**Type I-A Permit Modification to Solid Waste
Management Facility Permit and Waiver
Request for Additional Information #2
Application No. 2020-50565
Phase IV – Four Hills Landfill
Nashua, New Hampshire**

**NHDES Site #: 198403099
Project Number: 4905**

Date of Report: February 11, 2022

Re: Request for Additional Information (December 3, 2021)
Applications for Type I-A Modification to Solid Waste Management Facility Permit
and Waiver (2020-50565)
Phase IV Landfill Expansion, Four Hills Landfill
Nashua, New Hampshire
Permit No. DES-SW-SP-95-002

PROJECT NUMBER:	3066.11
SHEET NUMBER:	5 OF 30

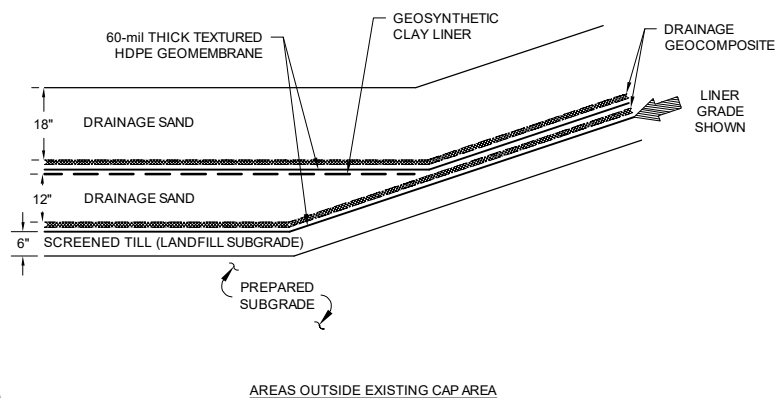
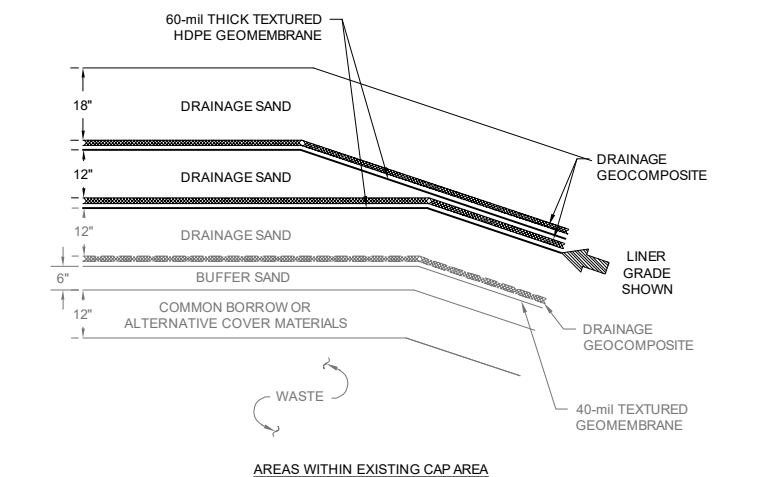
1. *NHDES understands that the City is proposing to monitor the quantity and analytical characteristics of liquid from a tertiary layer¹ beneath the Phase IV double-liner system and above the unlined landfill geomembrane cap. As discussed during our meeting on November 10, 2021, provide preliminary design plans and specifications as required by Env-Sw 315.05(c)(4)a, and any proposed changes to the facility's operating, closure and financial assurance plans as required by Env-Sw 315.05(c)(4)b, c, and d, needed to accommodate the proposed design.*

Sheets 13, 14, 16, and 17 of the Phase IV Design Drawings were revised to include the preliminary above-cap monitoring system design details. The above-cap monitoring system will function similarly to that of the proposed leachate collection and detection systems, whereas liquid captured within the existing Unlined Landfill capping system will be conveyed downslope to a 6-inch diameter perforated pipe that will direct the liquid to the

**Revised Phase IV Design Drawings
(Sheet 10A)**

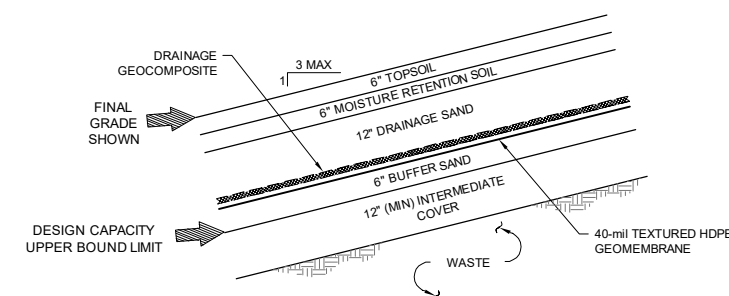
2. *Provide the proposed “approved design capacity” of Phases I through IV as defined in Env-Sw 102.09, and identify by showing on a grading plan the proposed vertical and lateral limits of waste used to determine the Phases I through IV design capacity so as to provide a complete description of the proposed modification in accordance with Env-Sw 315.05(c).*

To address Env-Sw 102.09(c), the proposed “approved design volume” (defined in Env-Sw 102.10) is included in the Facility’s Operating Plan and are repeated below. Also, to address Env-Sw 315.05(c), Sheet 10A (enclosed) was added to the Phase IV Design Drawings to clarify the volume calculation boundaries (i.e., top on intermediate cover).

PRIMARY GEOCOMPOSITE CRITICAL PATH (POST-SETTLEMENT)

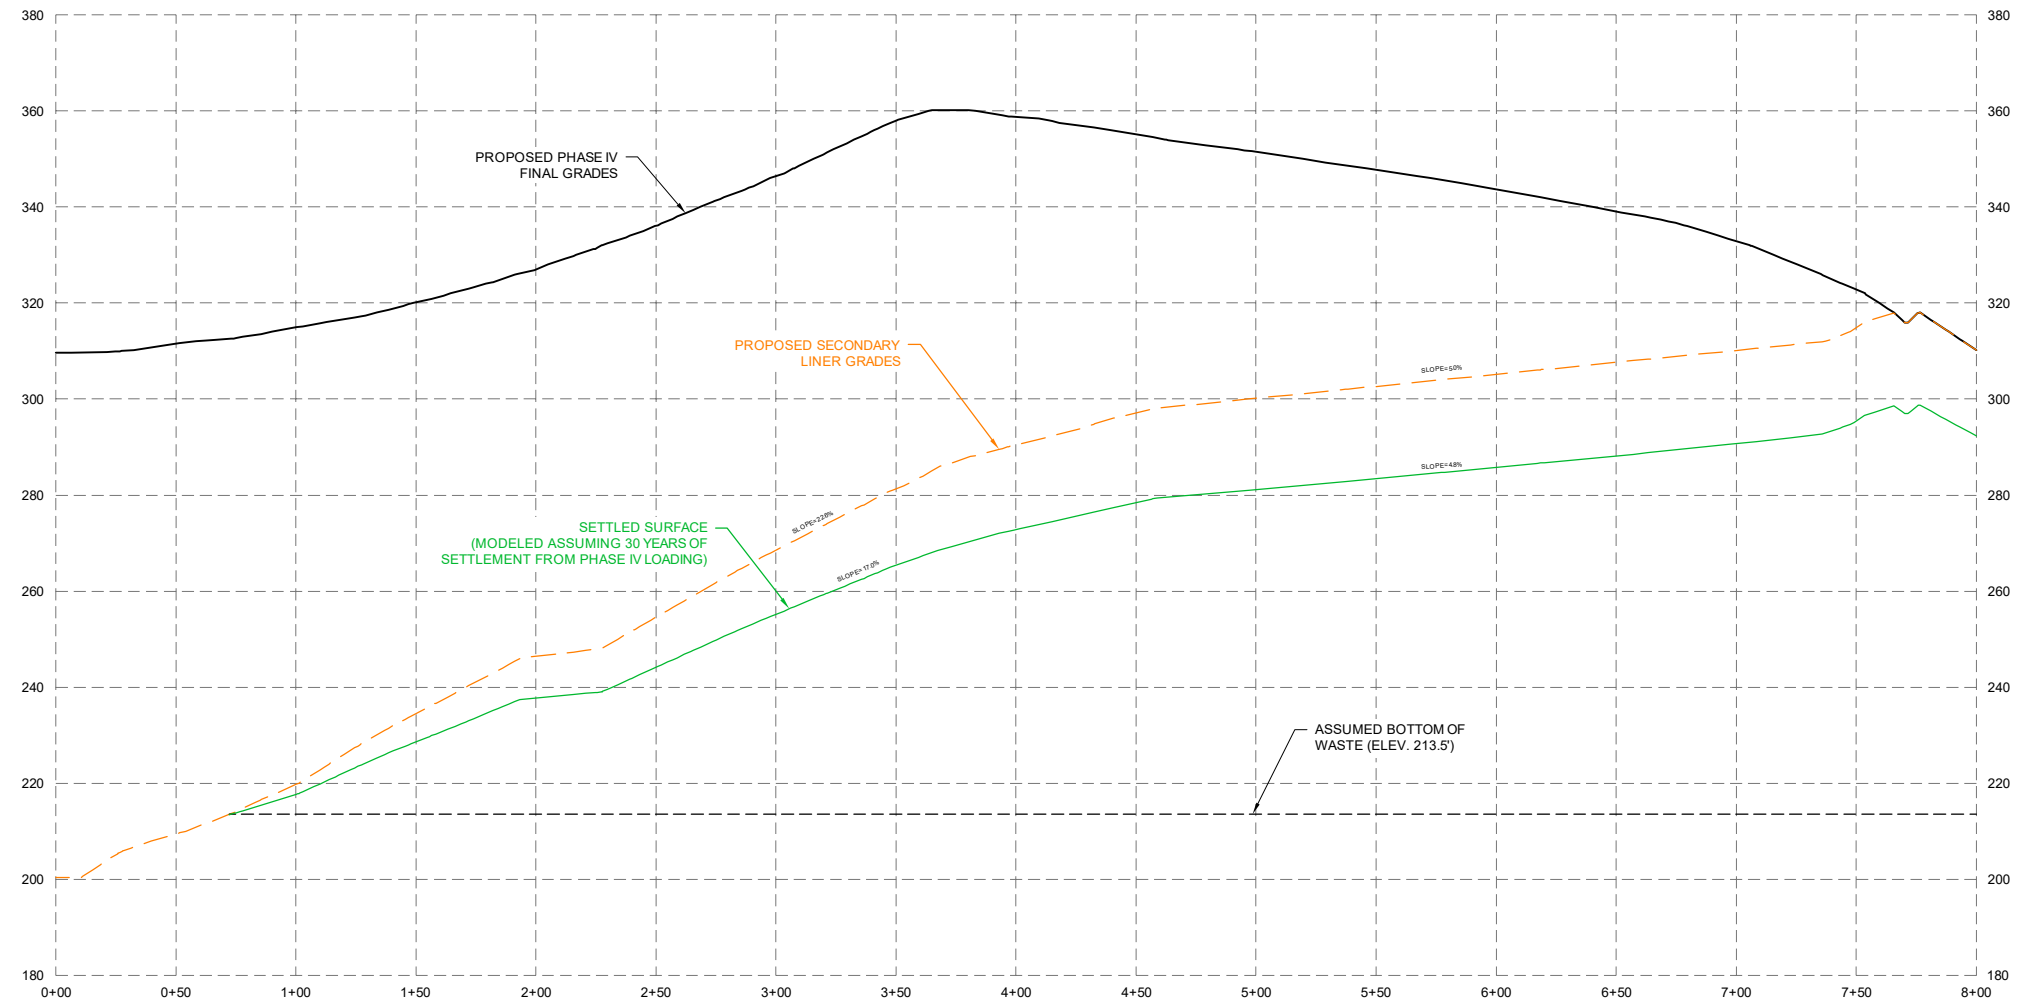
c. Provide an explanation and supporting calculations to demonstrate that the proposed Phase IV systems can accommodate anticipated settlement, including whether the leachate collection and removal systems will function effectively during both the active life and closure and post-closure periods of the landfill in accordance with Env-Sw 805.06(d). NHDES anticipates that leachate removal calculations will be performed for both the pre- and post-settlement conditions to capture the full extent of the system’s performance over time.

the critical path as depicted on the enclosed Primary Geocomposite Critical Path Profile Worksheet. As depicted on the profile, the slope of the “top deck” drops from 5.0% to approximately 4.8% and the sideslope average slope drops from 22.6% to 17.0%. The enclosed Table 1 was modified to include these post-settled slopes and the resulting calculated required transmissivities. As noted on Table 1, the performance requirement for the primary drainage geocomposite does not change as the maximum required transmissivity still occurs within the Phase IV base during initial operations (i.e., $1.69 \times 10^{-3} \text{ m}^2/\text{sec}$).

Revised Gas Monitoring Well Location Plan

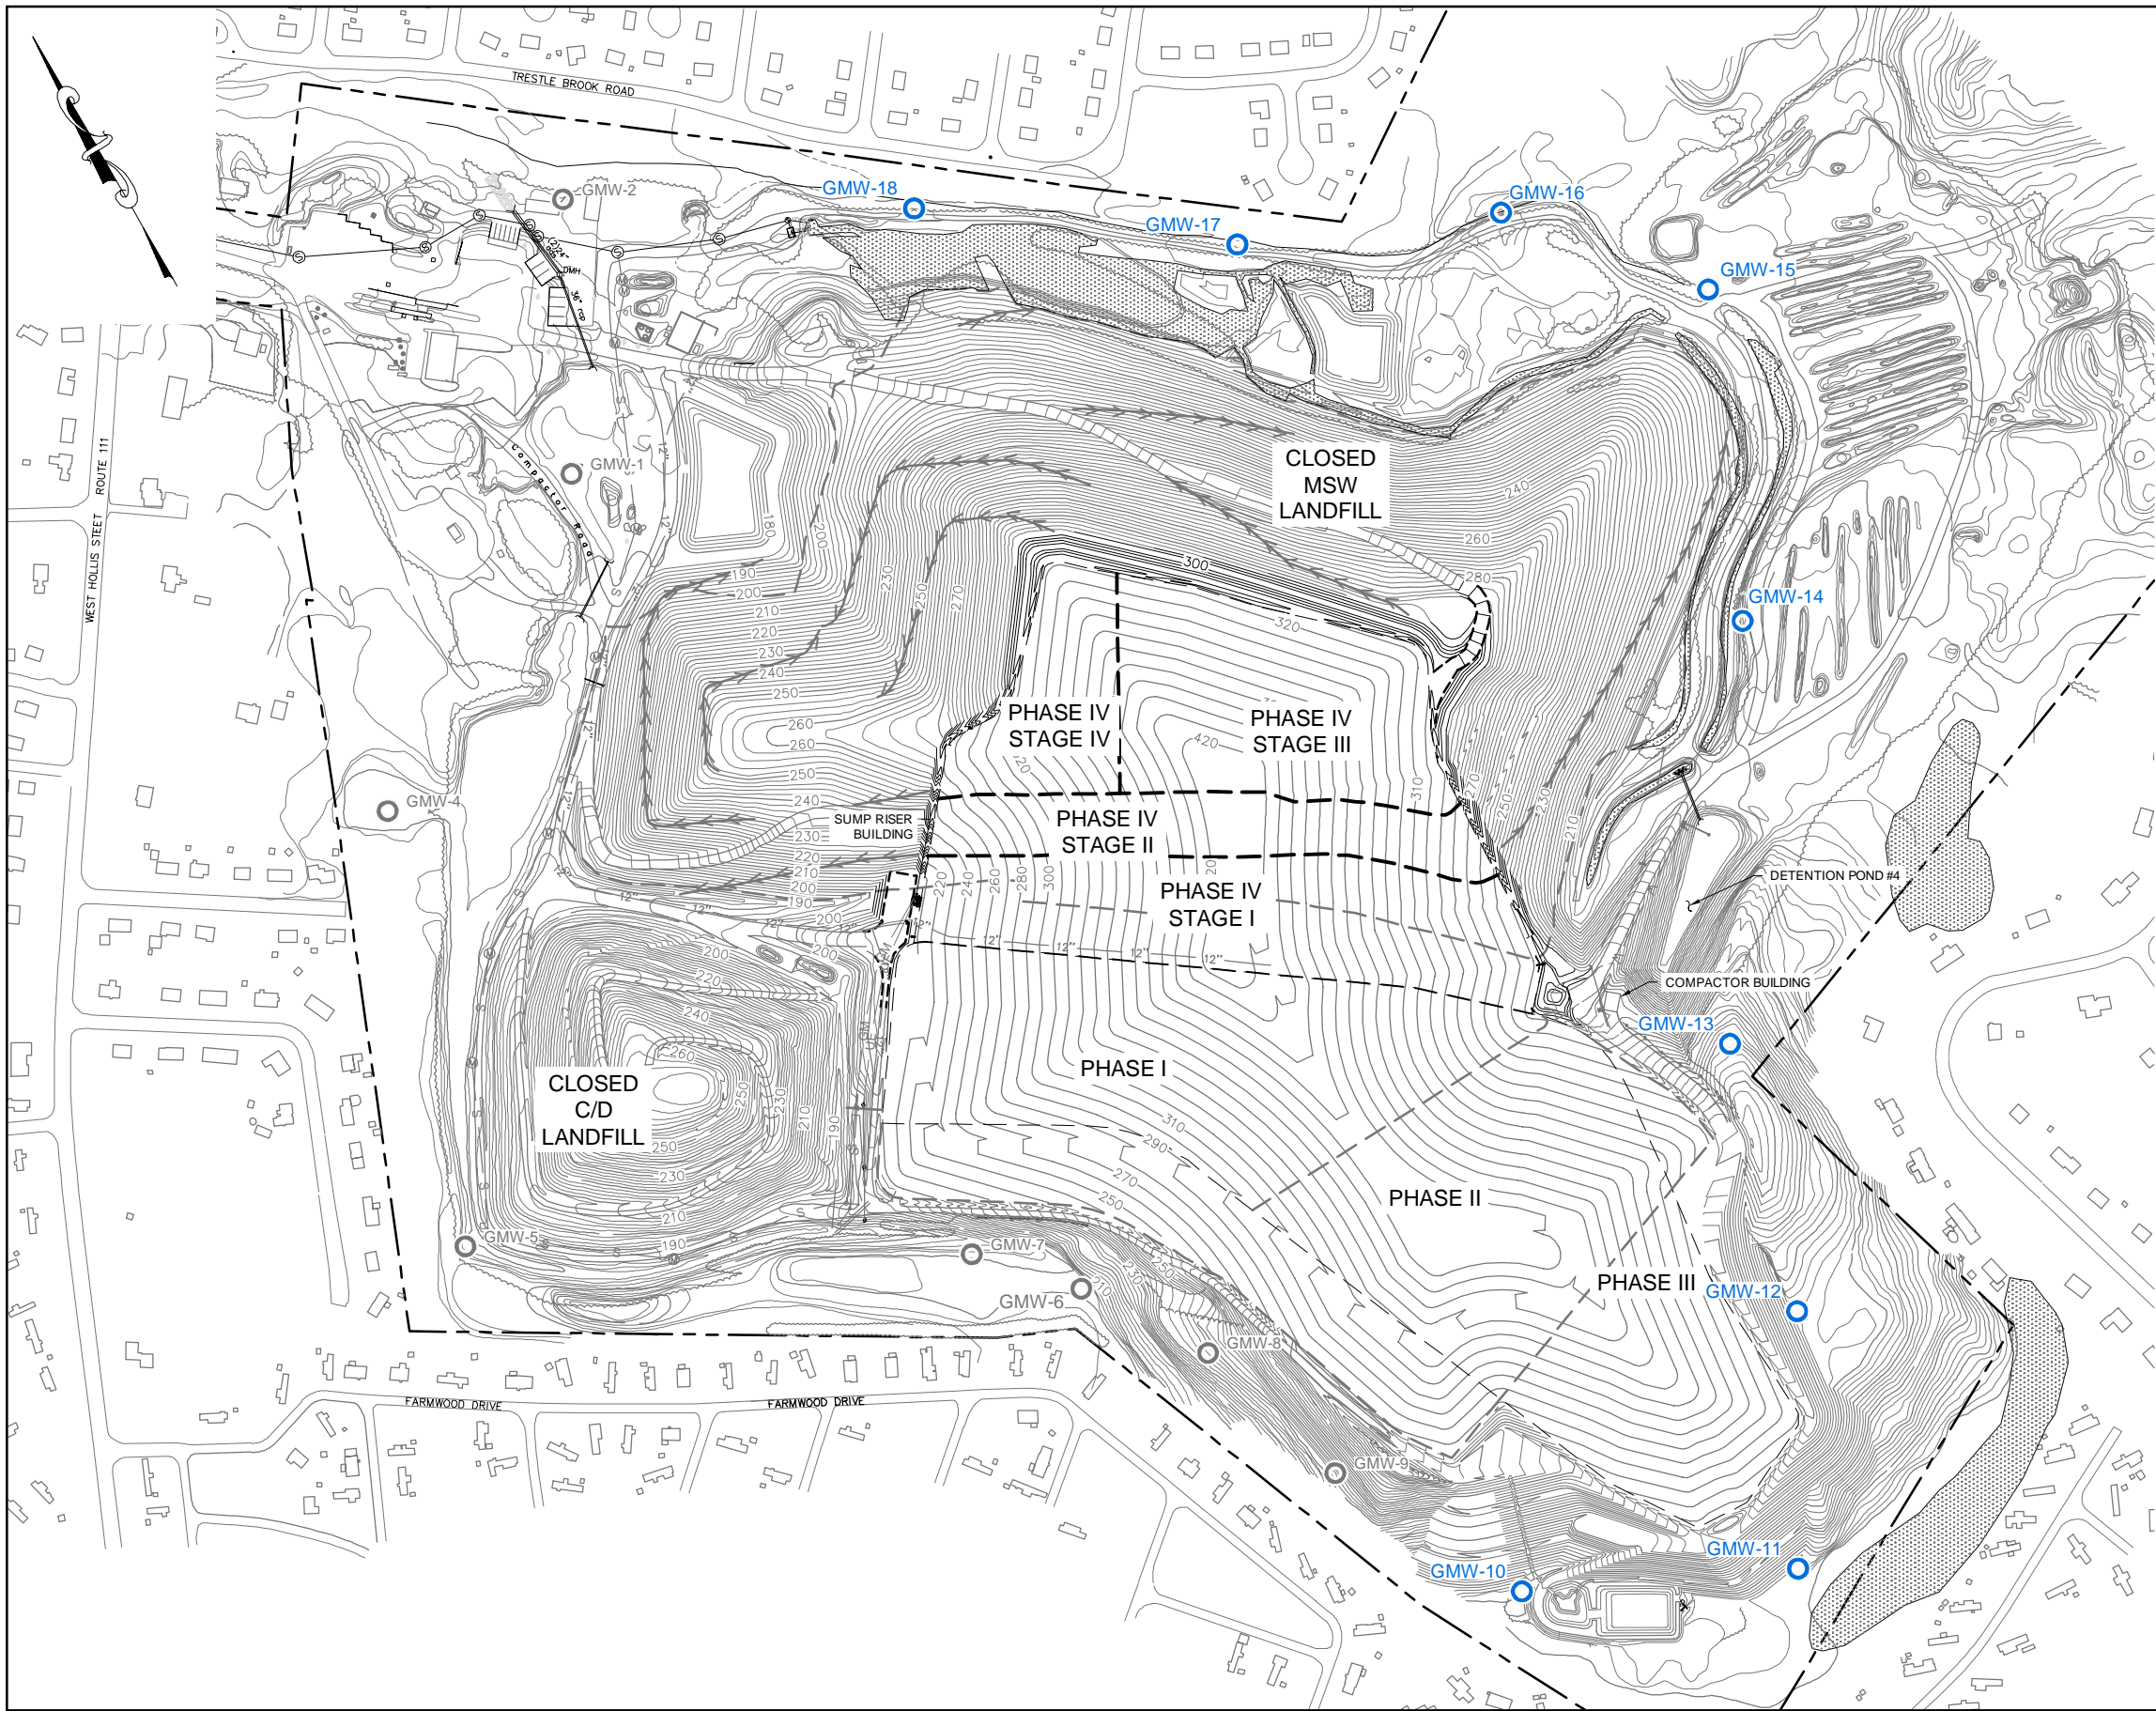
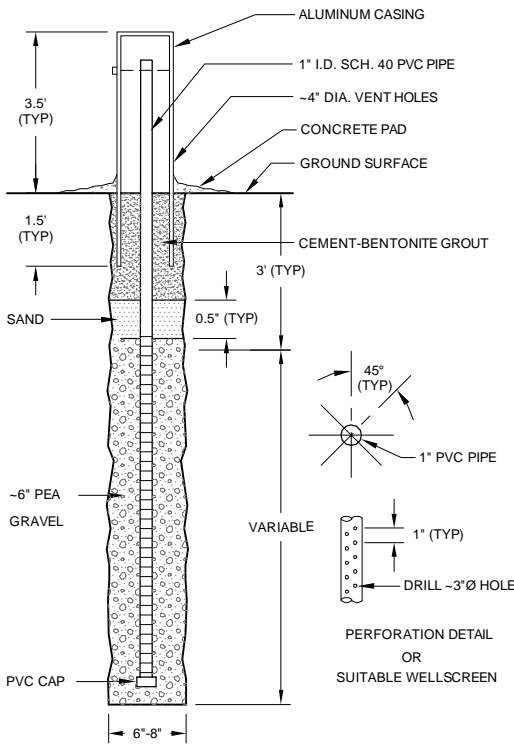
5. *Provide preliminary design plans for expanding the decomposition gas monitoring network to ensure the requirements of Env-Sw 806.07 will be met. NHDES notes that there are no gas monitoring points positioned to monitor for migration along the westerly boundaries of the facility beyond which lie residential developments.*

A revised Gas Monitoring Well Location Plan is enclosed that depicts the existing gas monitoring network and proposed locations along the northern and eastern boundary of the facility. The proposed monitoring point spacing is limited by access constraints but is consistent with that of the existing monitoring locations (i.e., up to approximately 500 feet between locations).
